## Architect's Supplemental Instructions

**PROJECT:** *(name and address)*  
17-13 OSU College of Med. at Hastings  
Tahlequah, OK

**ASI INFORMATION:**  
ASI Number: Bid Pack 03 - ASI 01  
Date: 4/22/19

**Bid Package 03- ASI 01 – OSU College of Osteopathic Medicine At The Cherokee Nation**

KEY PLAN			
PROJECT PHASE: BID PACKAGE 03			
#	DATE	REVISIONS	DESCRIPTION
1	4/28/19	BID PACKAGE 03 ABL/01	
DATE: 03-20-19		JOB NUMBER: 17-13	
SHEET NUMBER:		S3.11	
FOUNDATION SECTIONS

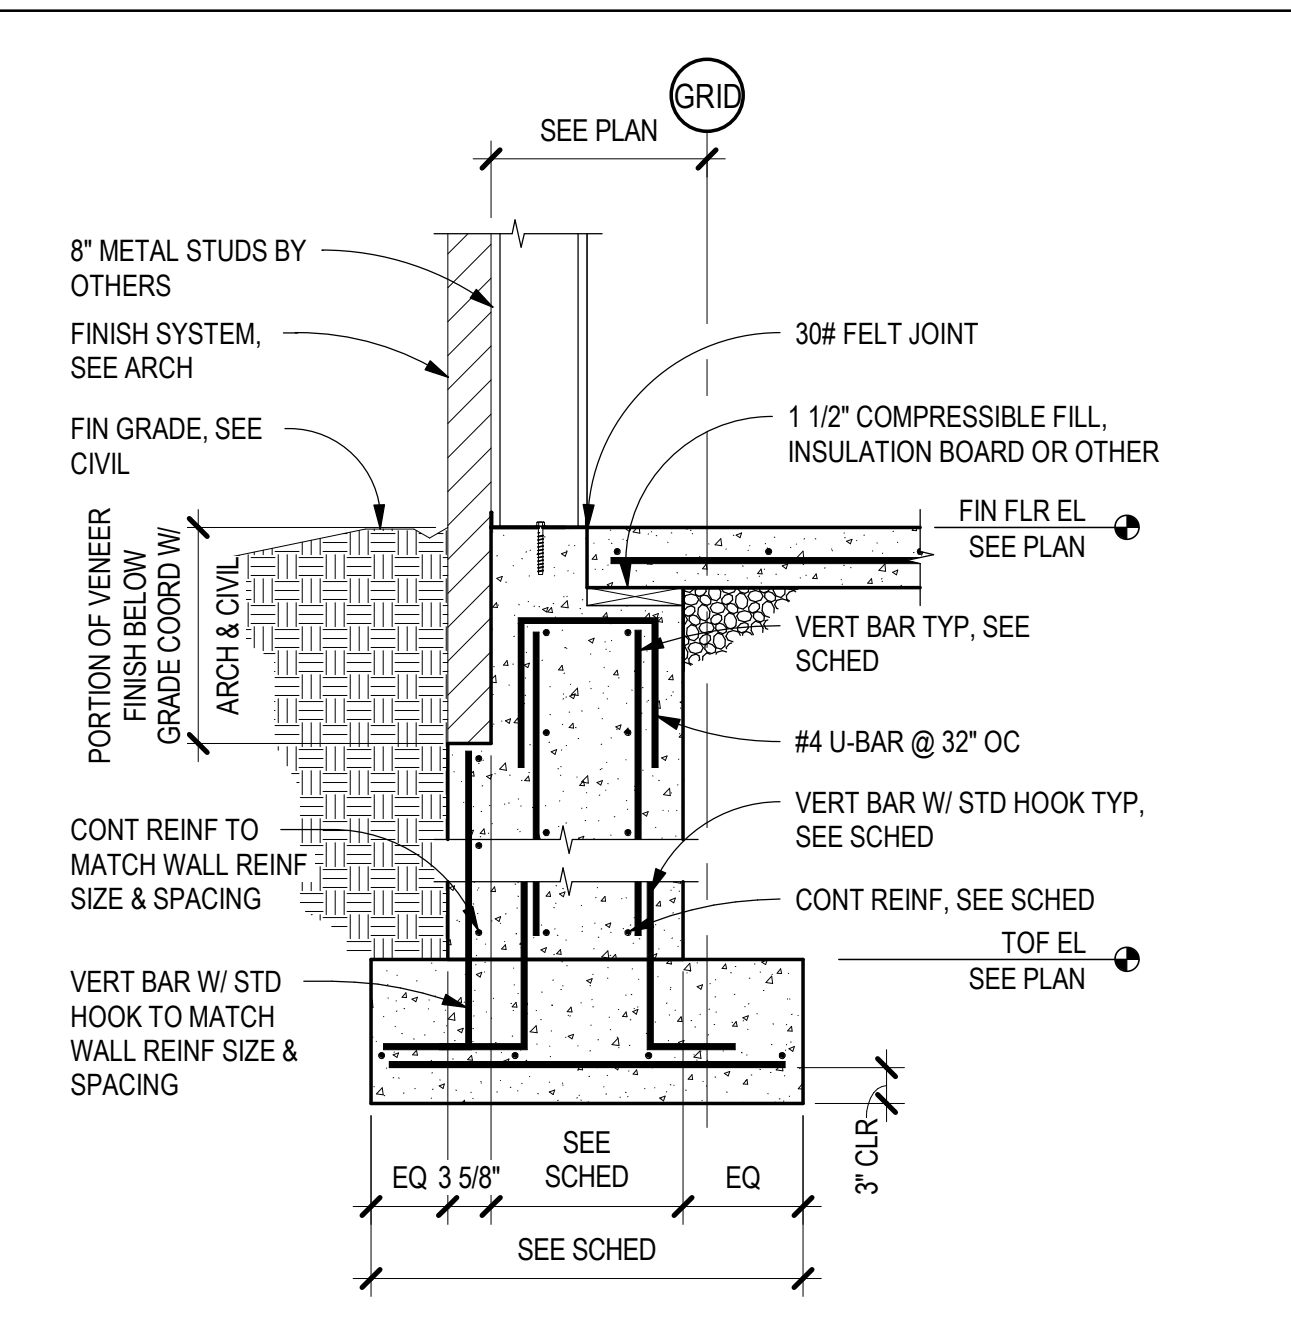
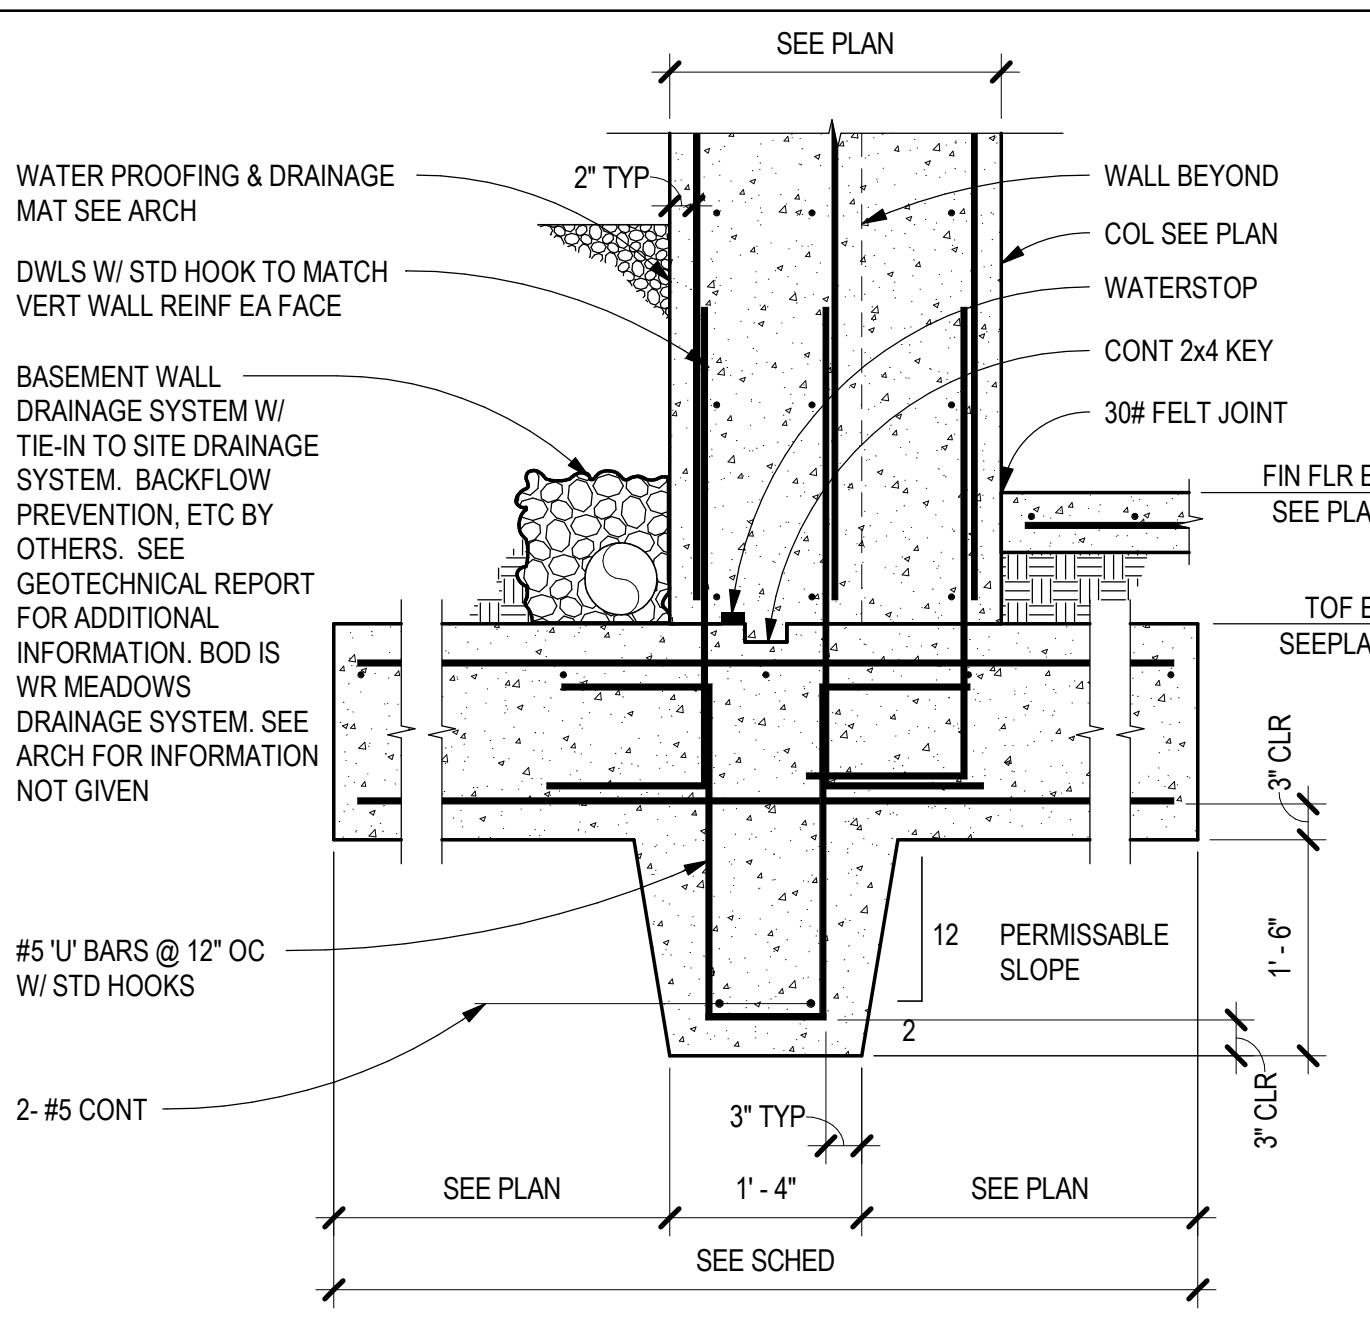
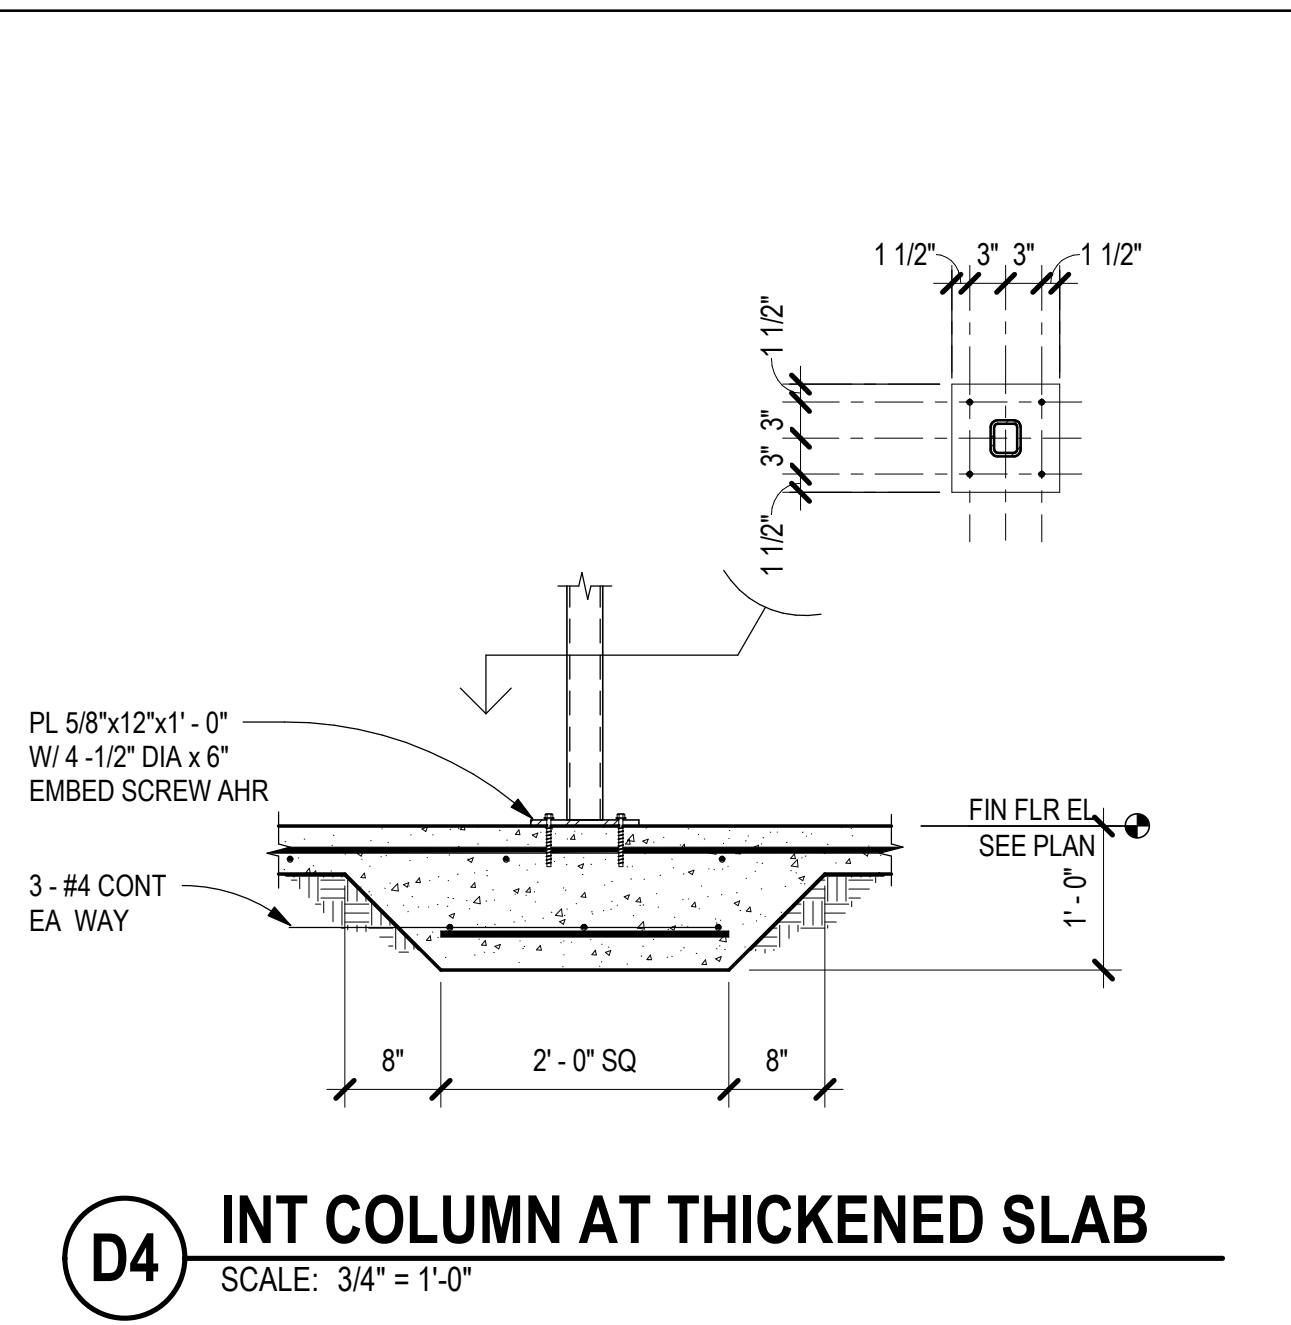
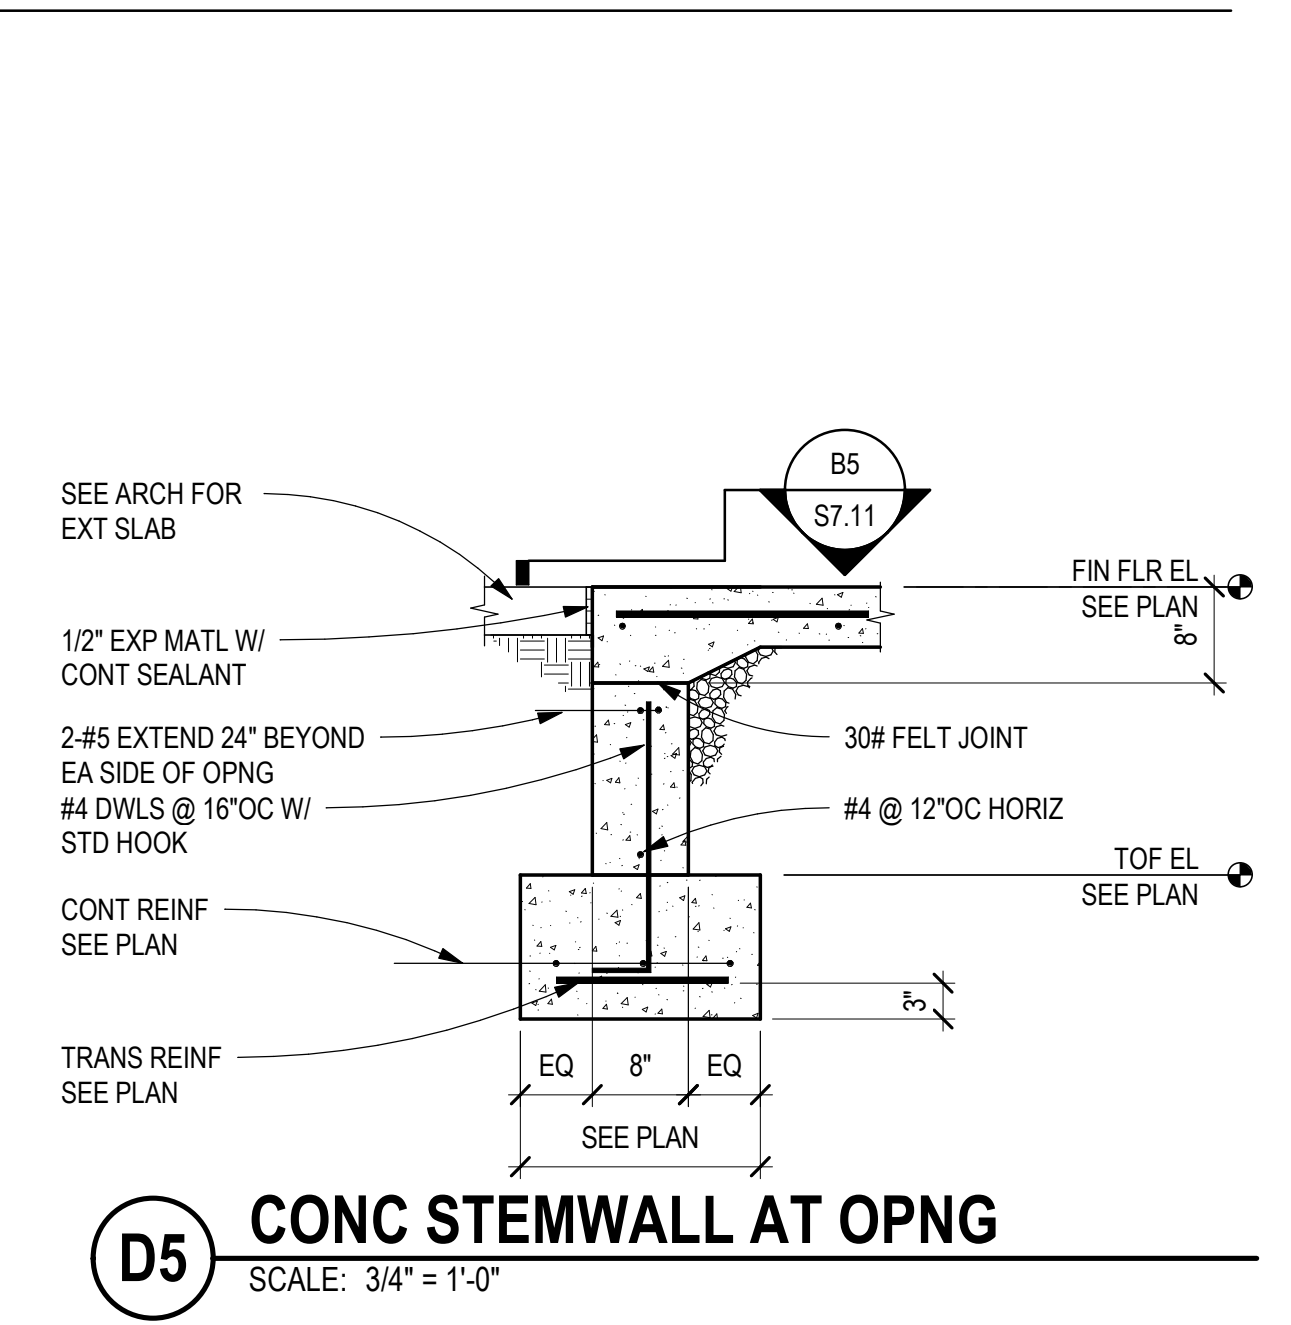
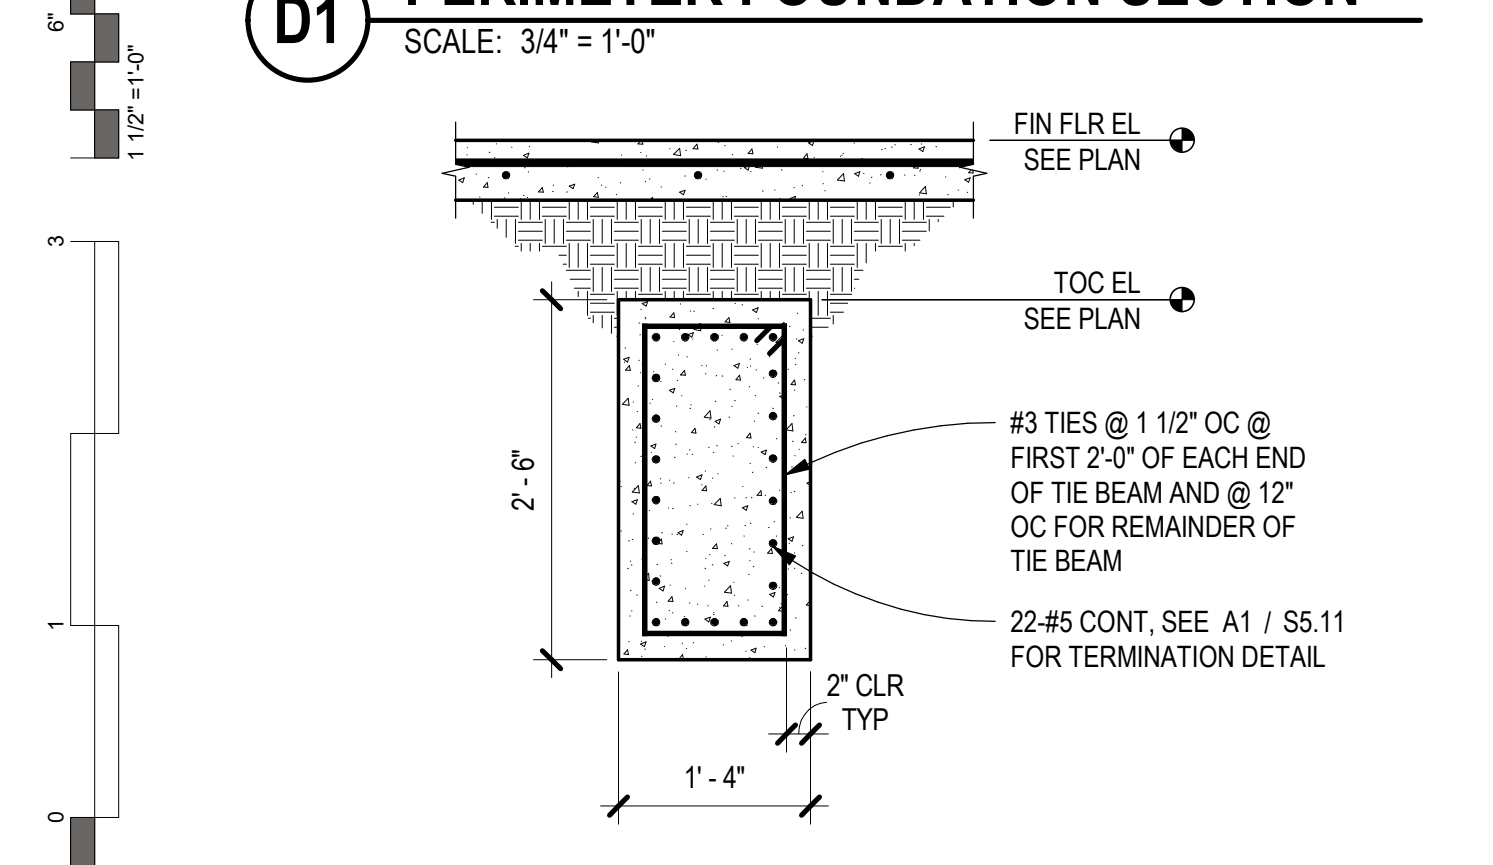
S3.11	Entire sheet revised.
S3.12	Detail D5 revised.
S4.02	Canopy support post size and quantity along Grid 1 revised.
S4.02	Canopy support beam sizes along Grid 1 revised.
S4.02	Thickened slab added to plan A4.
S5.11	Detail D1 added.
S6.01	Slab-on-grade schedule revised.
S6.01	Spot footing and continuous footing schedules revised.
S6.01	Detail A1 revised.

ENTIRE SHEET REVISED
